MICE Integration Engineering

Jason Tarrant - STFC

- Contents
 - » Device Interfaces – General
 - » AFC
 - » Spectrometer Solenoids
 - » RFCC
 - » EMR / KL
 - » South Mezzanine (summary)

- » Geometry

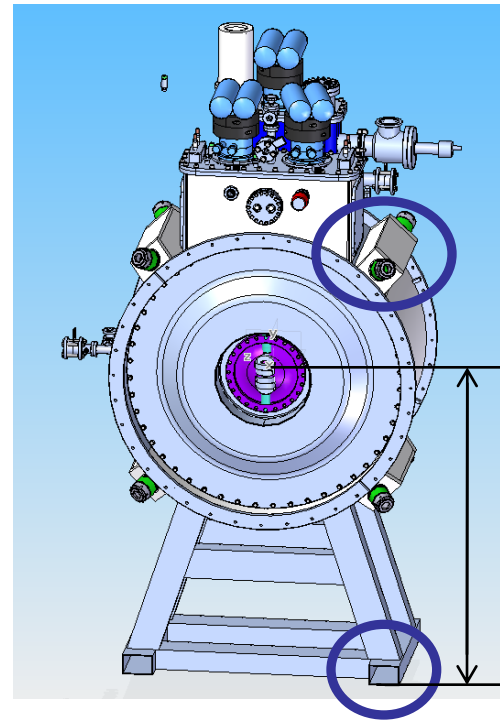
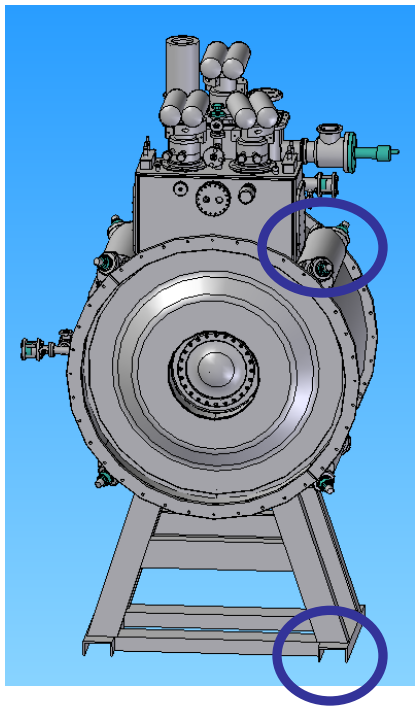
- Tesla support system modifications = suspension system turrets changed (model received 3/7/11)

1534!
Asked to change
back to 1515

- » Geometry

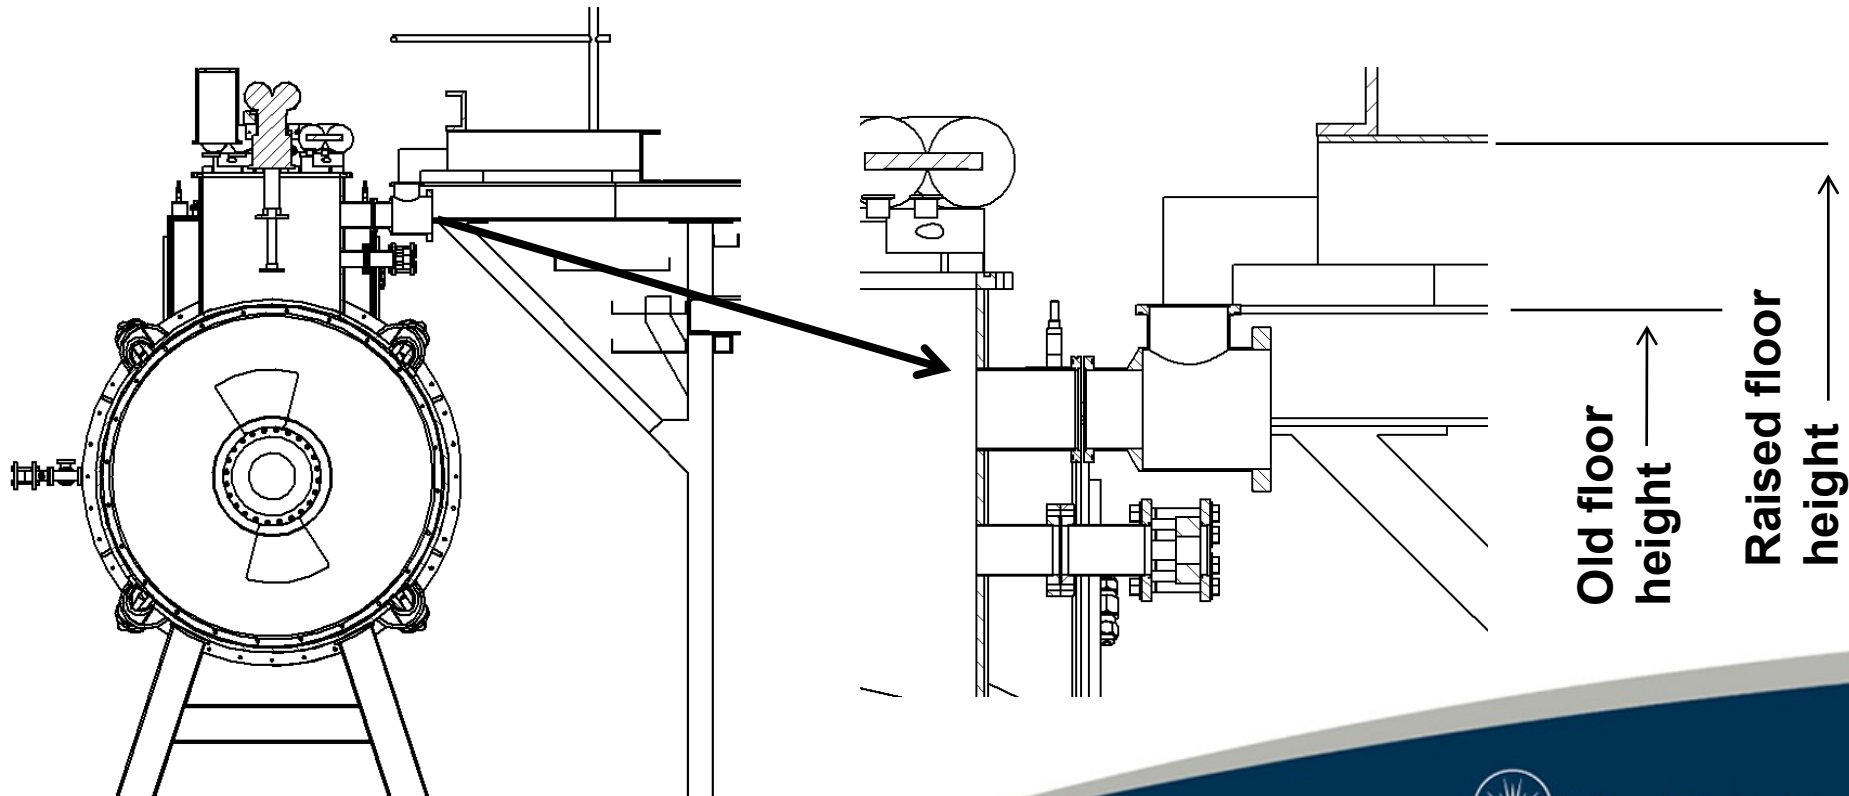
- Hydrogen Safety Vacuum Line clash with South Mezzanine

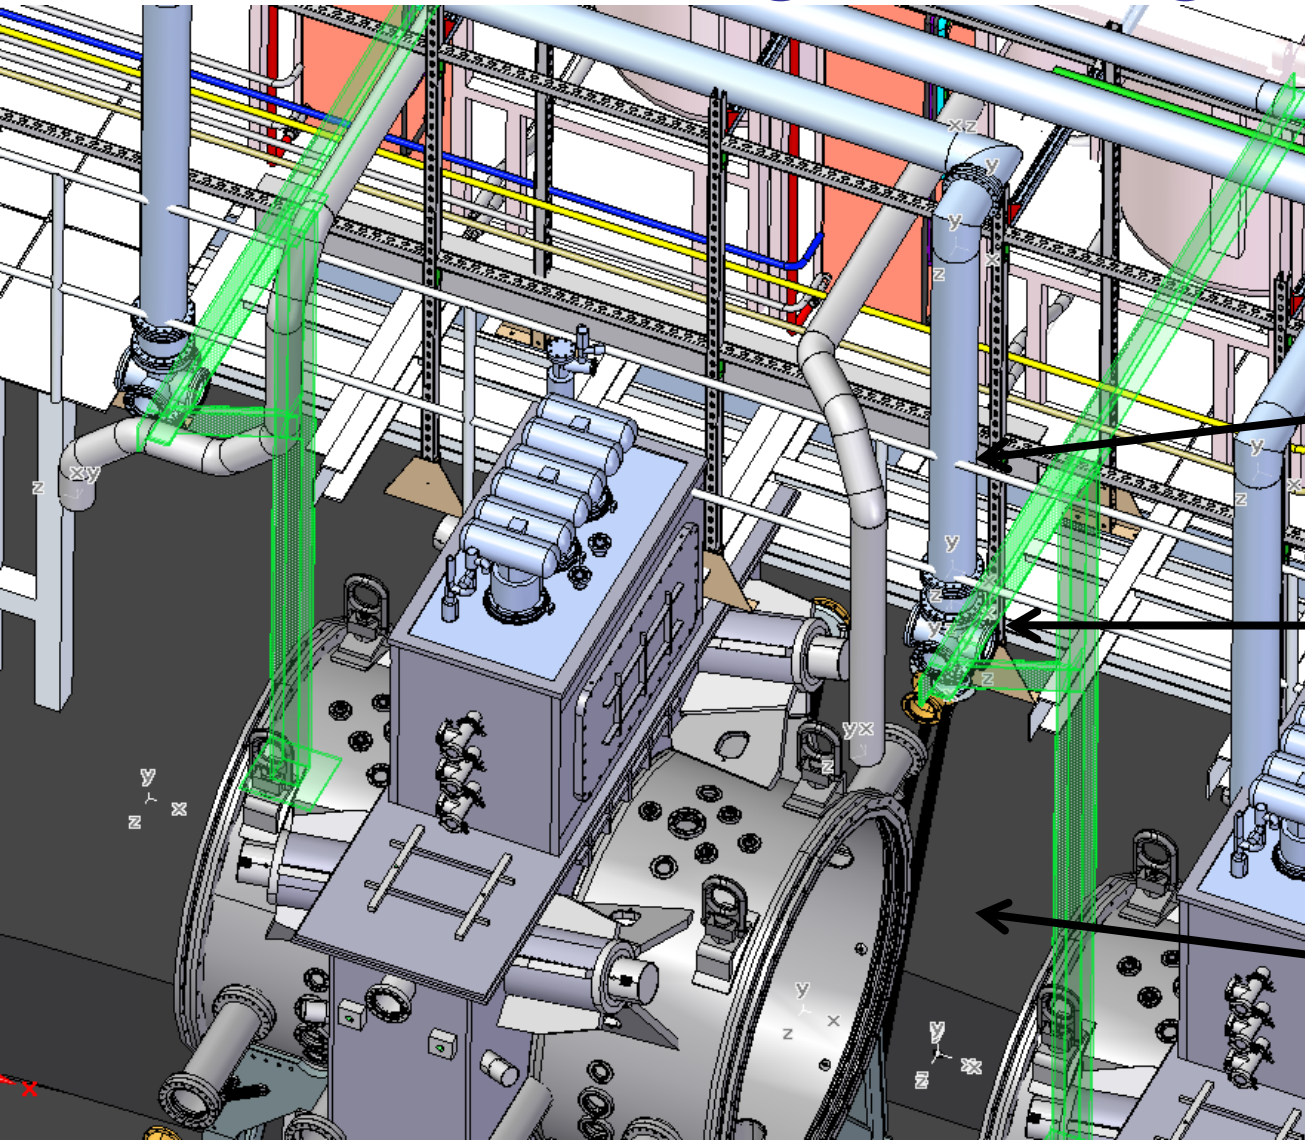
Clash with rails

Clash with support leg

AFCs not shown so vacuum pipe run can be seen

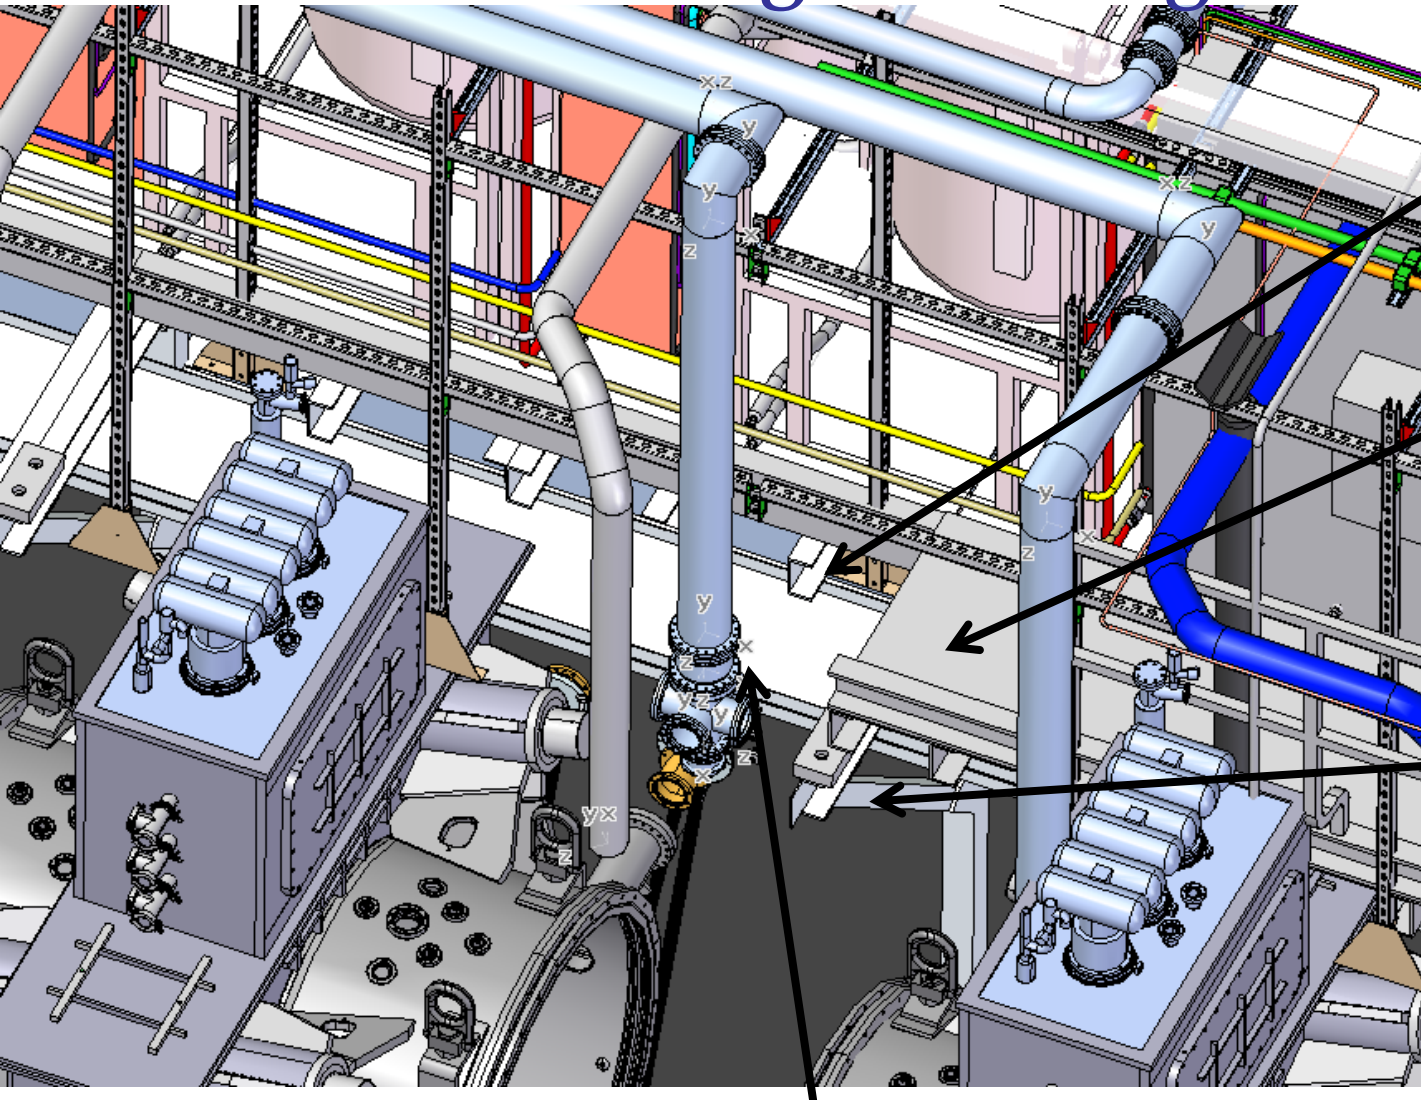
Beams cut back

Raised & narrowed floor section
(removable but H system parts temporarily moved)

Support leg moved to next beam

Cut required in floor panel around vacuum pipe

- Spectrometer Solenoid
 - » Interface with rolling platforms

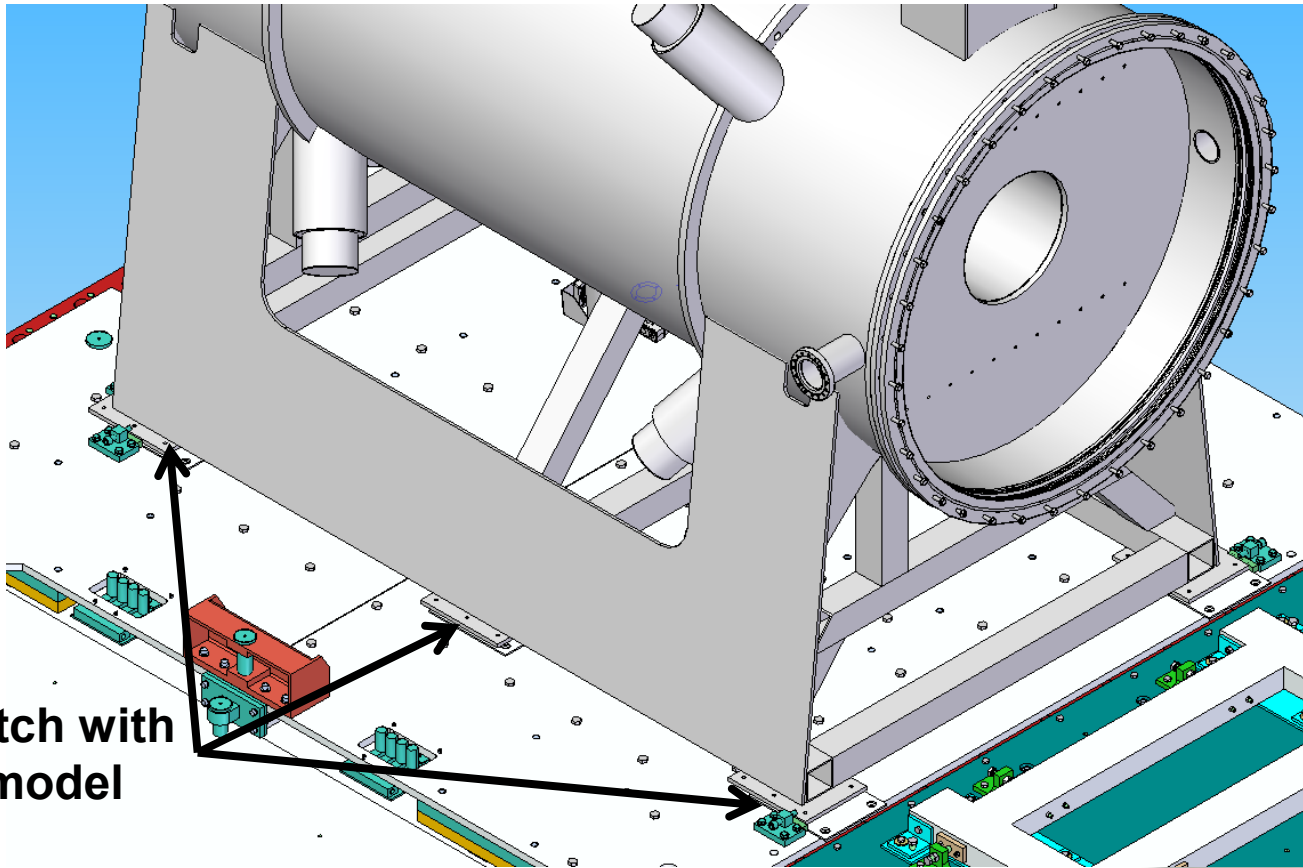
Mismatch with latest model

- » Geometry

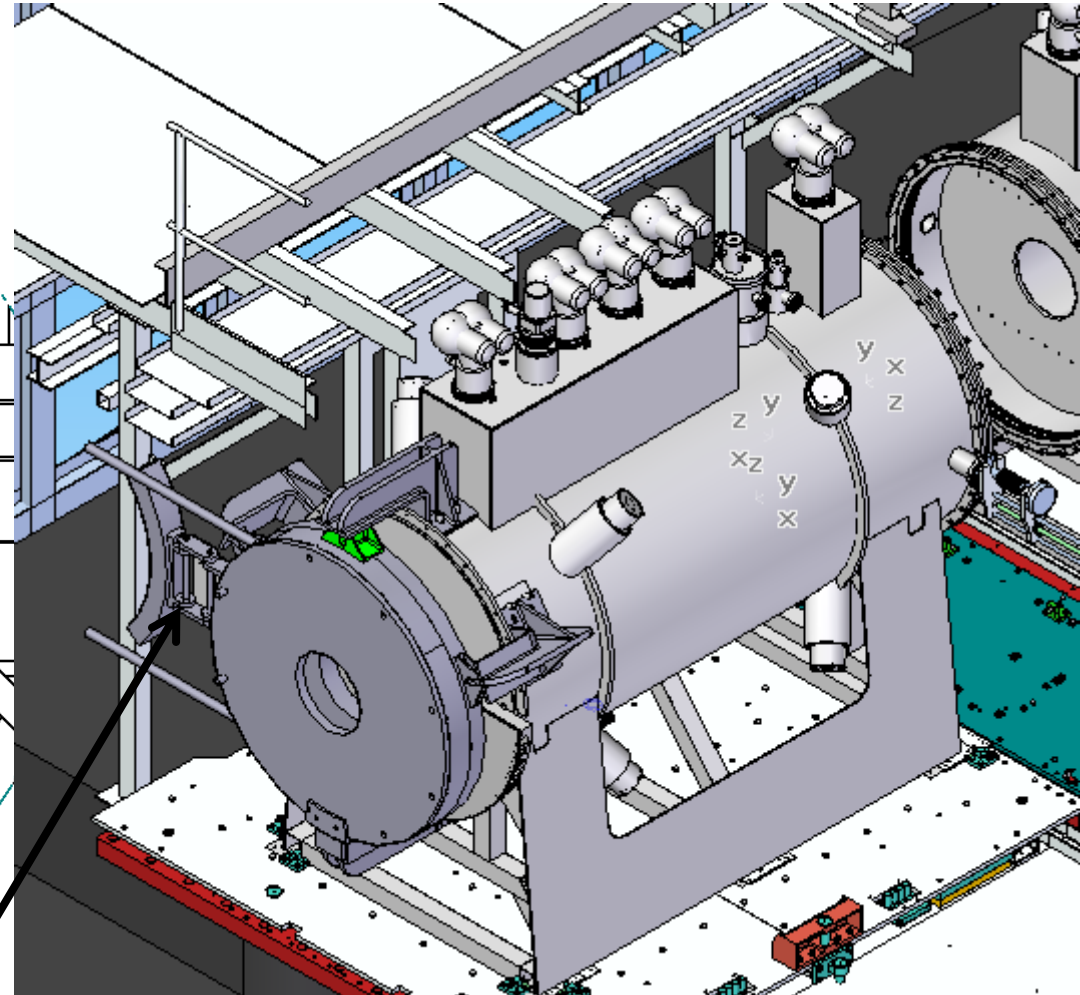
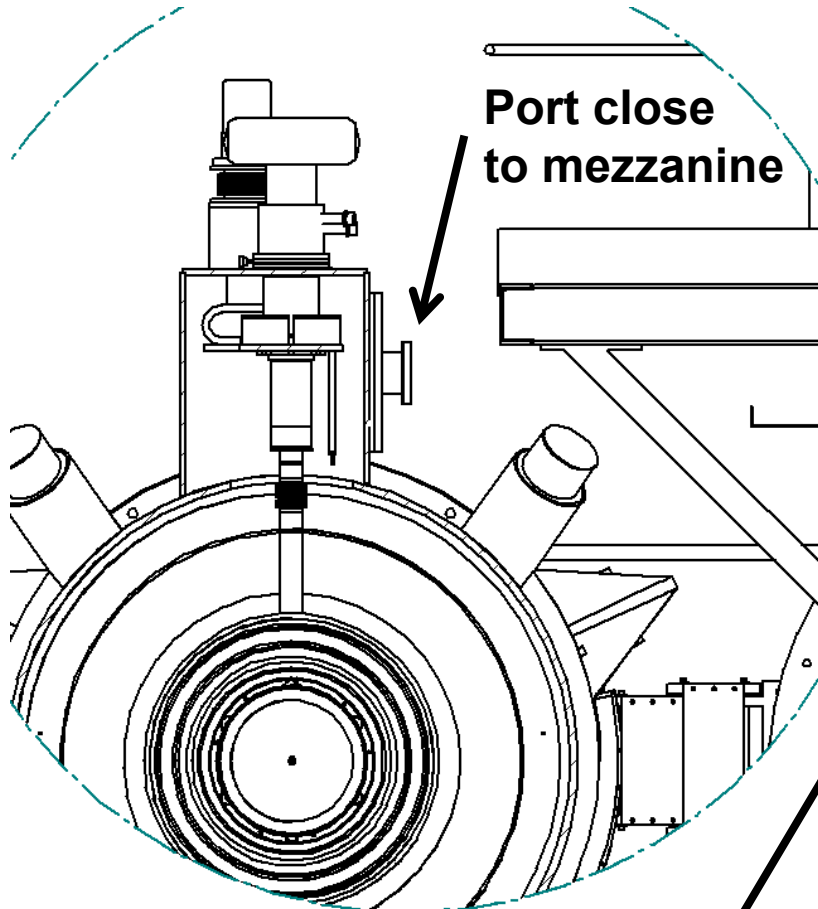
Rotate for convenience?

- Spectrometer Solenoid
 - » Geometry

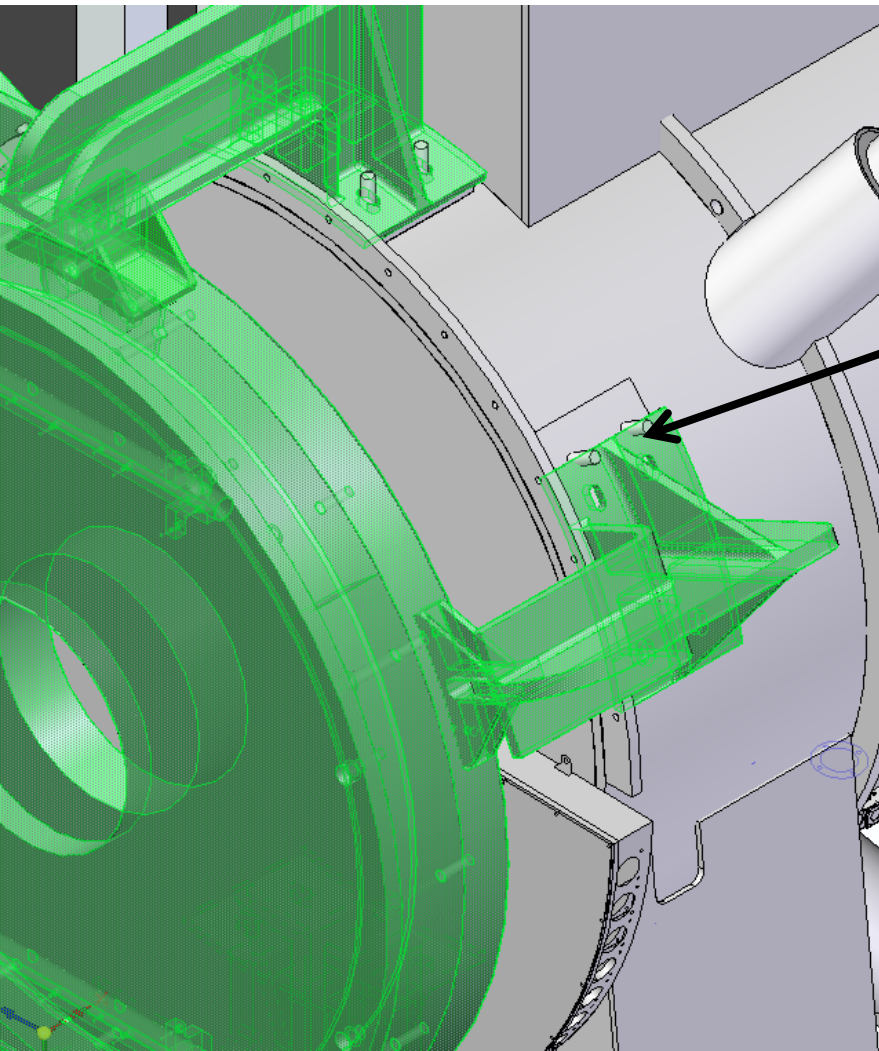
**Brackets not align
with latest model**

- Mezzanine & EMR

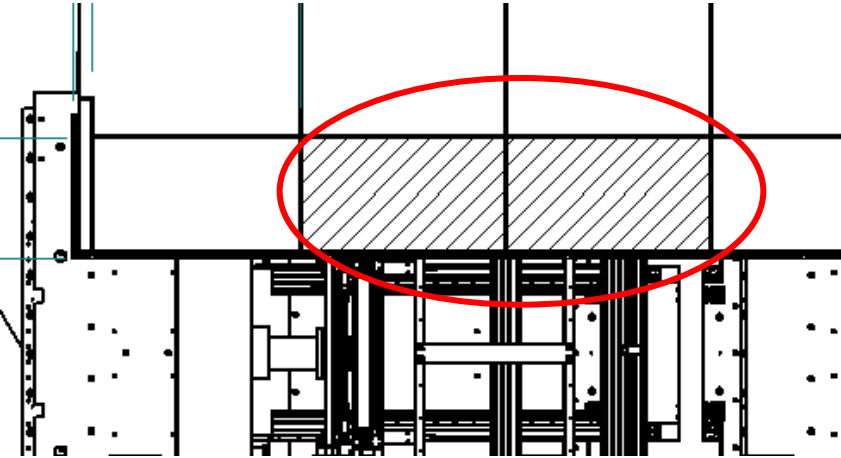
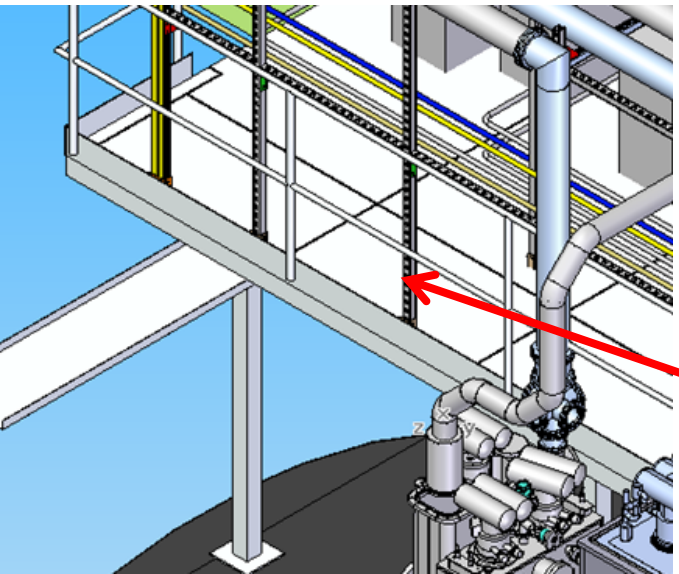
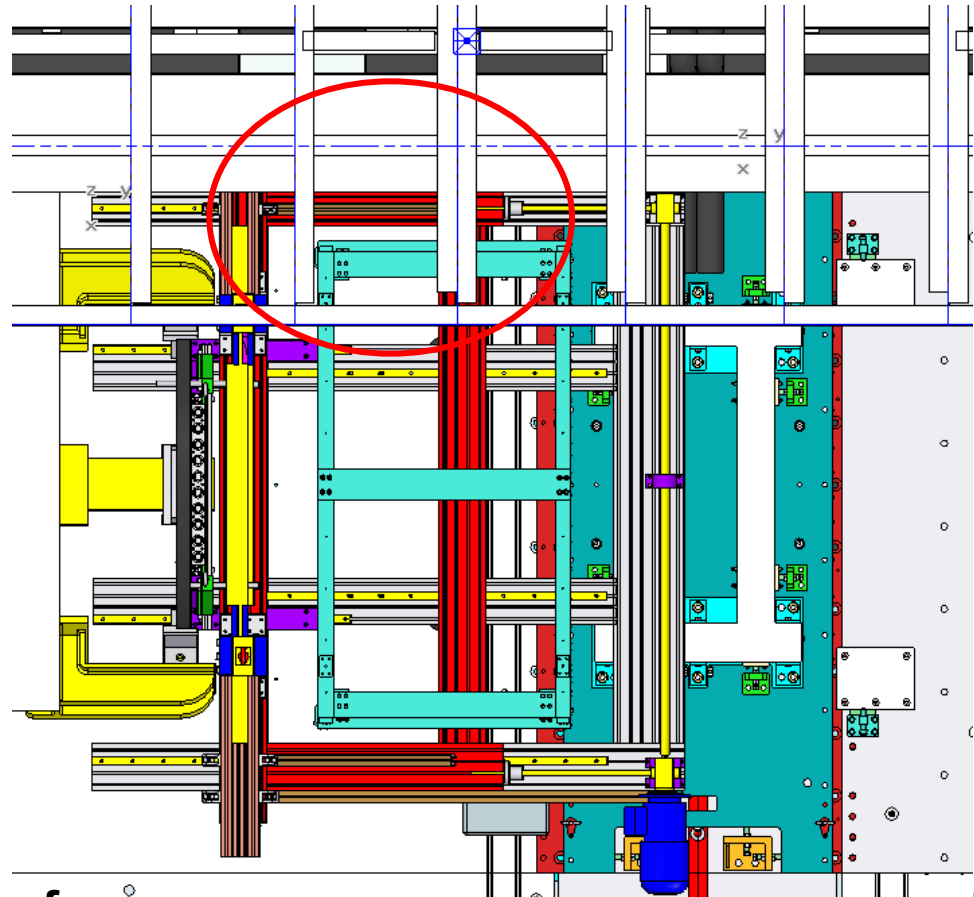
Floor plates removed

Beams cut back

Hydrogen frame
clash (work postponed)
